# Supplementary Consultation Document

London Biggin Hill Airport – Airspace  
Change Proposal

This is a **Supplementary Consultation** conducted by London Biggin Hill Airport about the proposed introduction of an Instrument Approach Procedure to Runway 03 at London Biggin Hill Airport.

Figure 1: Original proposal in blue; revised proposal in red (overlaid on OS mapping)

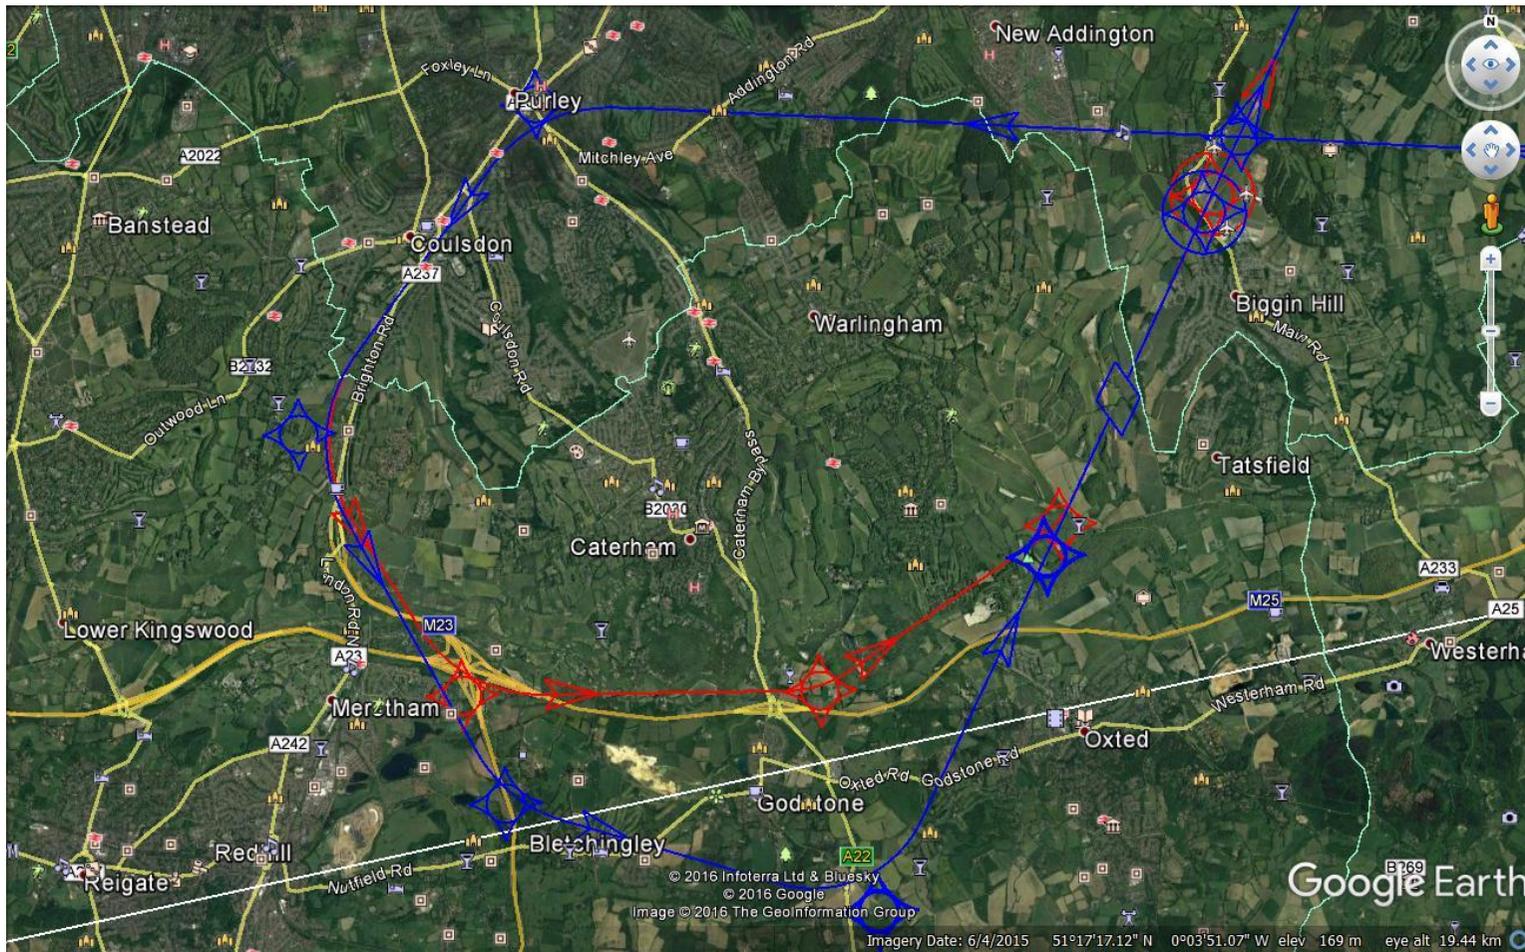
- 4.3. Thus, for the revised IAP configuration, descent from 3000ft to 2000ft commences between waypoints ARRO3<sup>7</sup> and ARRO4 (as before), but a requirement to be not above 2400ft at waypoint ARRO4 is added. At the same time the IAWP and Intermediate Waypoint (KB03I) have been repositioned some 0.94NM north-west and 1.75NM north respectively of their previous positions in order to ensure that the 2000ft level segment of the IAP remains outside the Gatwick CTA. As a consequence, arriving aircraft carrying out an IAP will leave 3000ft approximately 2NM earlier than under the original procedure configuration and will be below controlled airspace (on descending through 2500ft) from approximately 1.3NM before ARRO4 onwards. The realignment of the Initial Approach Segment shortens the procedure as a whole by approximately 2NM.

- 4.4. The realignment of waypoints IAWP and KB03I results in the Initial Approach Segment lying along the M25 between Junctions 7 and 6. This in itself alleviates a number of the environmental objection areas identified in the initial consultation and is discussed further in **Section 6** of this document.

- 6.5.1. As noted in **Section 3** above, in resolving the interactions between the proposed IAP and Runway 08 departure procedures from LGW, it proved necessary to realign the IAP away from the Gatwick CTA. This has been achieved by relocating waypoints IAWP and KB03I together with specifying a “not above 2400ft” altitude limitation at waypoint ARR04.
- 6.5.2. The relocation results in waypoint IAWP being moved approximately 0.94NM north-west of the original position (to approximately M25 Junction 7) and KB03I being moved approximately 1.75NM north of the original position (close to M25 Junction 6). As a result, the segment IAWP – KB03I is aligned closely adjacent to the M25 itself.
- 6.5.3. Thus the adverse impact of the proposed IAP on the communities of Bletchingley, Godstone and Tandridge to the south of the M25 is alleviated by the redesign of this part of the procedure.

Figure 3: Draft IAP Chart for the revised IAP (NOT FOR OPERATIONAL USE)

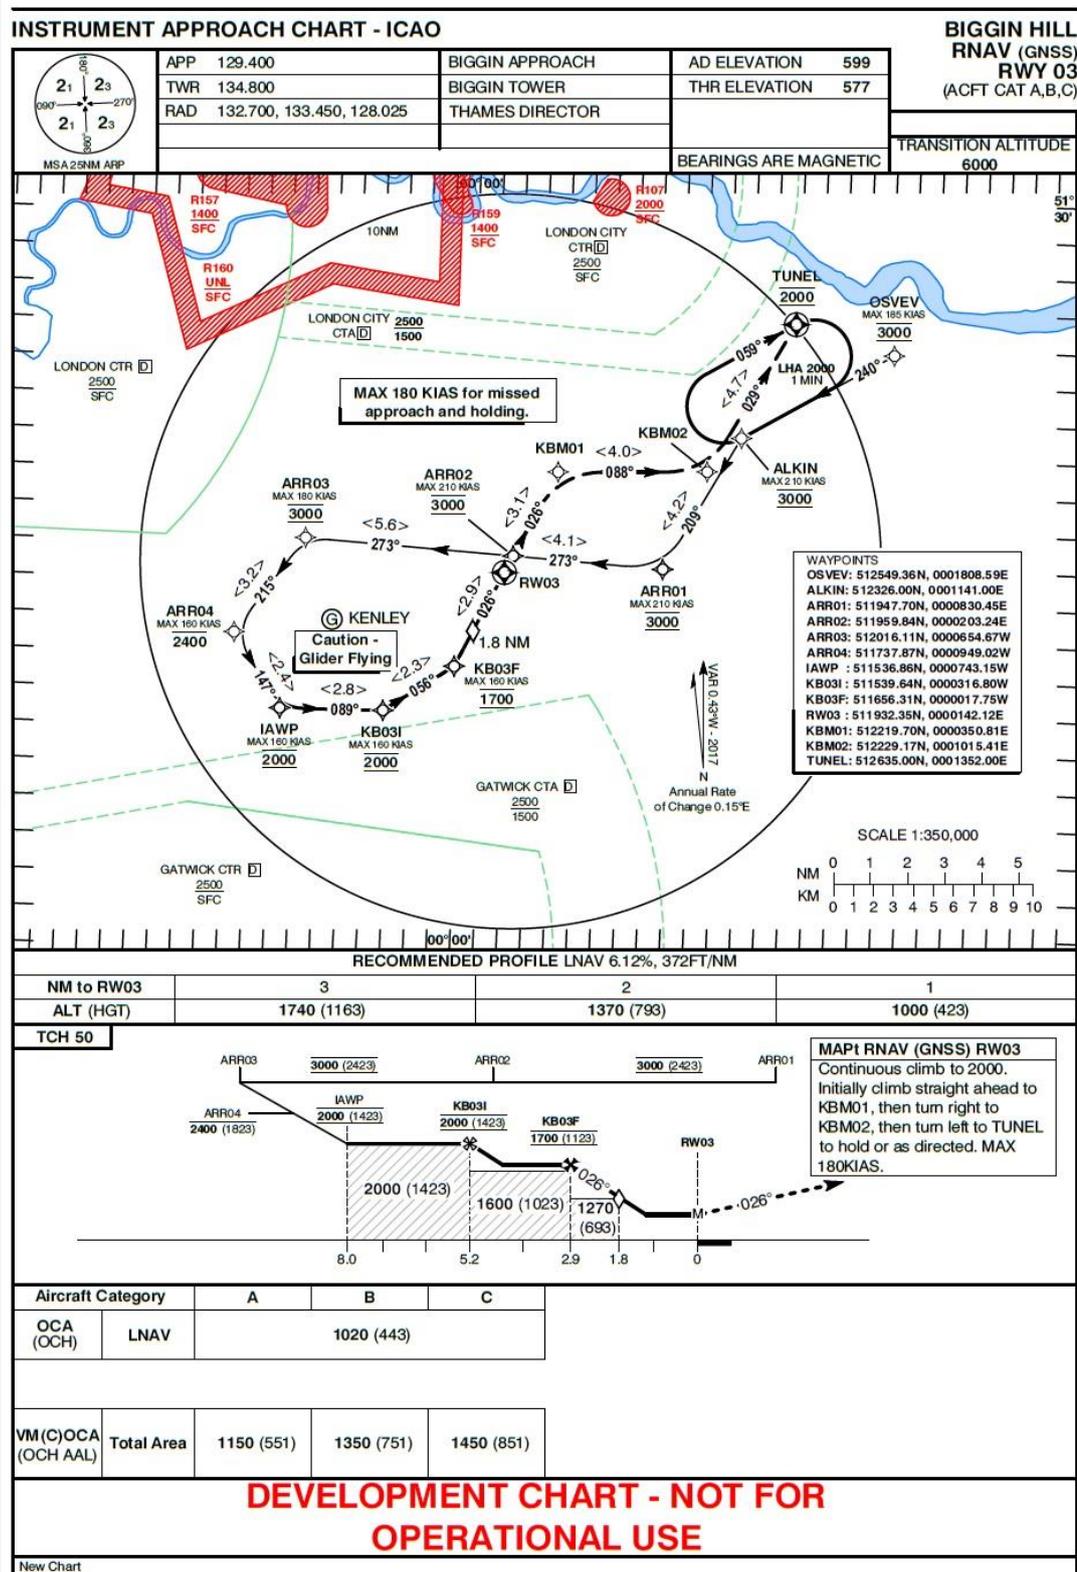
- 2.7. As a consequence of the changes to the proposed IAP, it has been necessary to alter the categorisation of the IAP to an Area Navigation (RNAV) Non-Precision (LNAV<sup>4</sup>) Approach only. The revised procedure configuration does not meet the full procedure design requirements for a Precision (LNAV/VNAV)<sup>5</sup> SBAS<sup>6</sup> Approach. This is discussed in **Section 4** below. However, in order that a viable IAP to Runway 03 can be introduced as soon as practicable, LBHA has elected to progress the adjusted Non-Precision procedure and will revisit the viability of introducing a Precision Approach at a later stage.

- 4.6. LBHA revisited the HAZID (Hazard identification) previously carried out for the original IAP configuration, as part of the Safety Management System (SMS) requirements, and applied the same safety analysis processes with similarly-qualified stakeholders. The results derived at the HAZID indicated that the IAP design within the airspace it would operate was tolerably safe<sup>8</sup>. We propose to add a Warning to the IAP Charts (subject to CAA acceptance) that

the IAP segments from ARRO4 onwards lie below controlled airspace in an area of regular VFR transit flights.
